ENGINEER'S DAILY REPORT

04-SF-80-13.2/13.9 Caltrans Supervisor:
Contract No. 04-0120F4 Gary Lai
{SAS Superstructure} Senior Bridge Engineer

REQUEST FOR INFORMATION (RFI) – ABF&SUB.RFI No.: RFI-BLI-000050R02 (ABF RFI 707) Submitted by: _____ Page(s): 1RFI Date: 7/16/07 Contact Name: Anna Lee Phone No. (415) 896-6072

Subject: Panels and Pullboxes at Tower Platform 53.85
References: RFI 707
Response required by: <u>7/30/07</u> (date) Response affects critical path activity? <input checked="" type="checkbox"/> YES <input type="checkbox"/> NO

RFI-706.707 SK-1
5/24/07

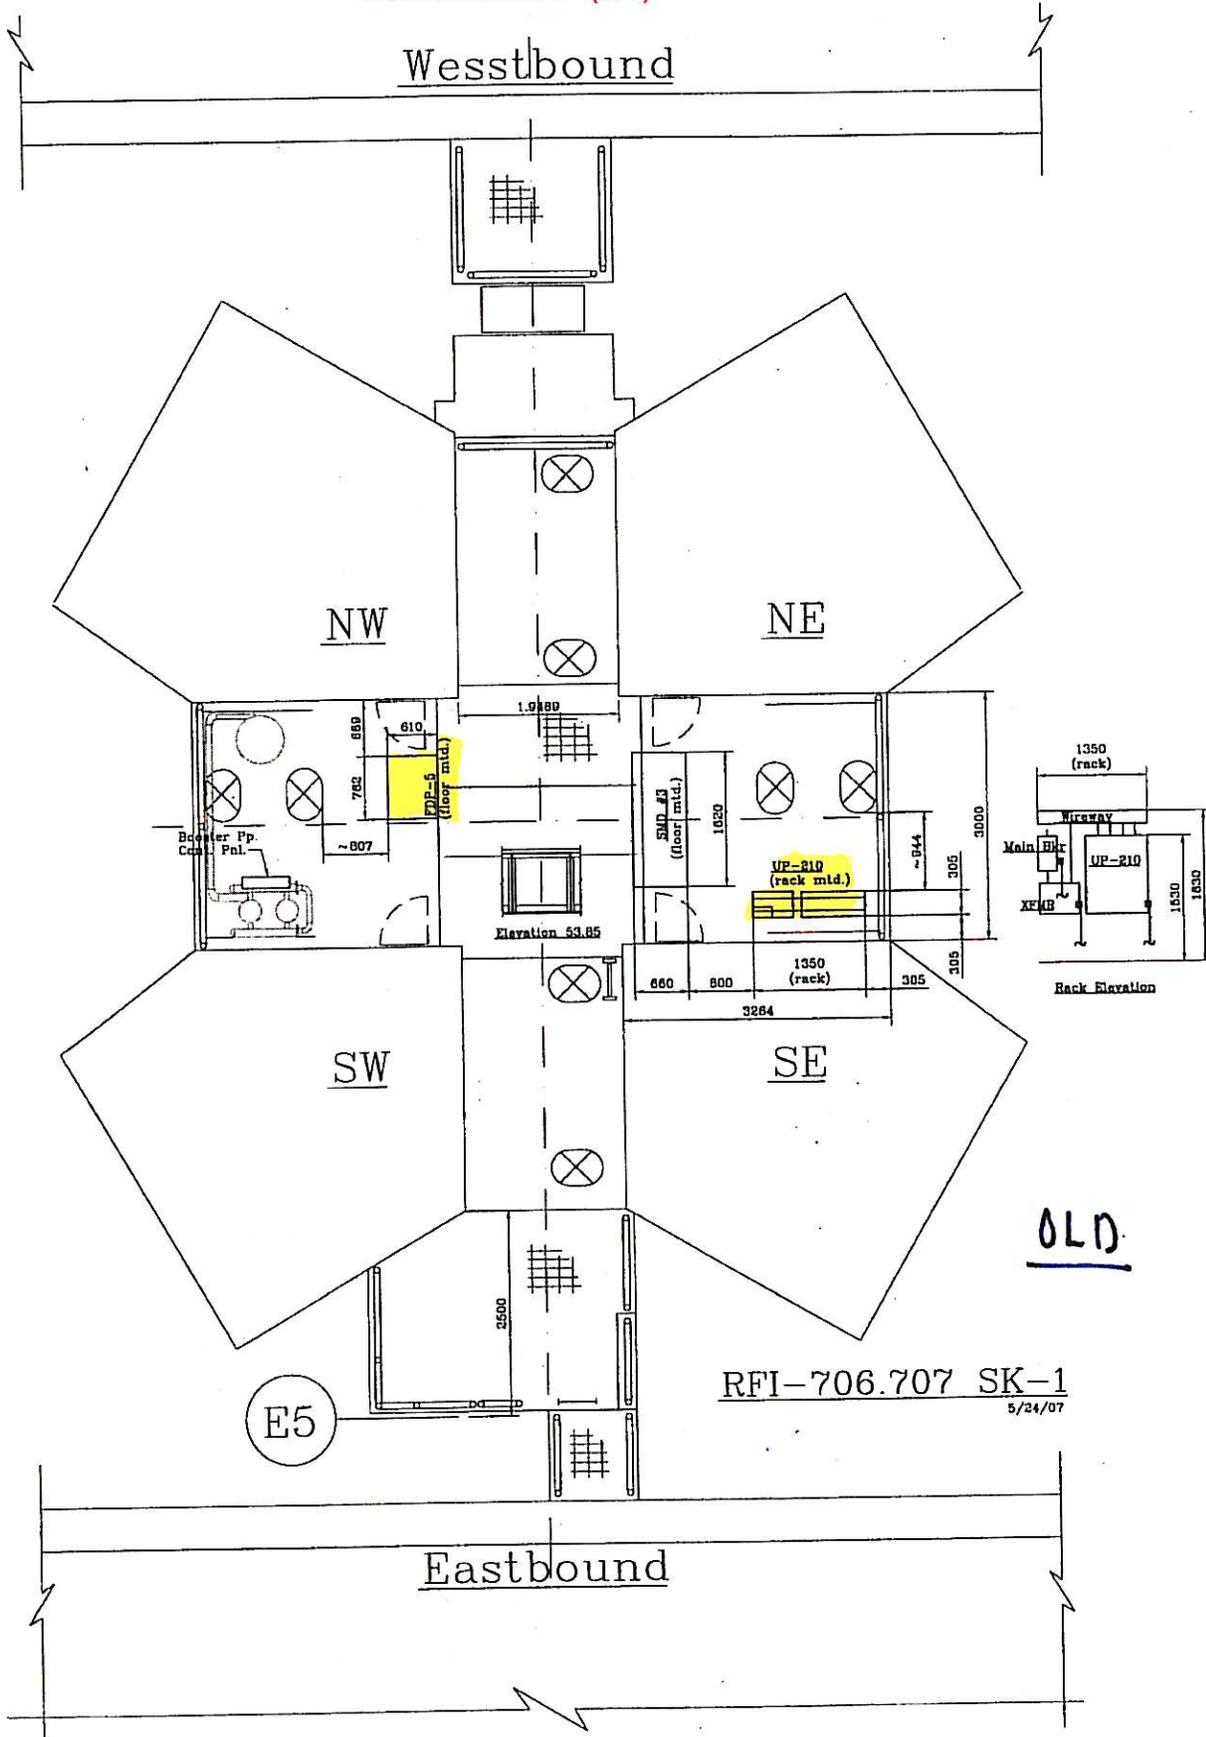
The reason for not locating the UP-210 behind the railing is because, the UP-210 rack, and all the spaghetti conduits going to the wire way shall be visible from the roadway level at 53.85.

Locating the UP-210 and rack between the NW and SW skin plate, opposite location from the strong motion panel shall hide the electrical installation from the roadway level. In addition, the FDP-5 which is floor mounted equipment (762 wide) maybe a lot smaller when we get all the information which most likely become a wall mount.

So, my conclusion, the revise arrangement is the way to go. Conduit rerouting, to avoid crossings is not a monumental task to change but the "appearance" shall be forever on the bridge.

- Contrary to the first statement, tower skin penetrations and attachments changed due to elevation changes for conduit routes. Equipment relocation to different quadrants resulted in previously run north-south conduits changing to east-west conduits.

- Sketch RFI-707-7.07 SK-1 lays out UP-210 using an incorrect dimension of 3264 mm for the SE-A plate. Please issue a corrected layout using 2750 mm for the A plate.

1. The conduits should not be visible from the roadway, don't want to deal with aesthetic issue.
2. The UP-210 be accessible for service personnel (door can be opened).
